There is so much wrong with the Jupiter EIS. Rather than saving it all for a book sized submission at the end, I will deliver it a chapter at a time.

Chapter 1

Where Mr Clouston publishes the worst set of photomontages in modern times.

SCREEN PLANTING EXAMPLE B

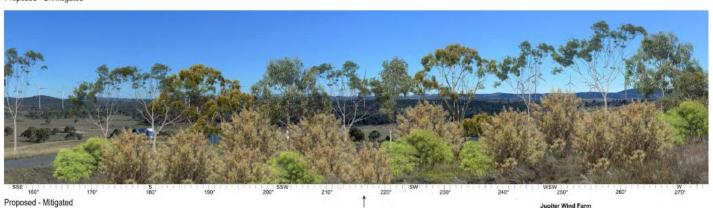
By the way, the view is far better than this. Naturally, as you diminish the impact of the turbines, you likewise diminish the original view of the landscape.

This mitigation nonsence enabled Cloustons to lower the Visual Impact for residence J3 from High to Moderate/High
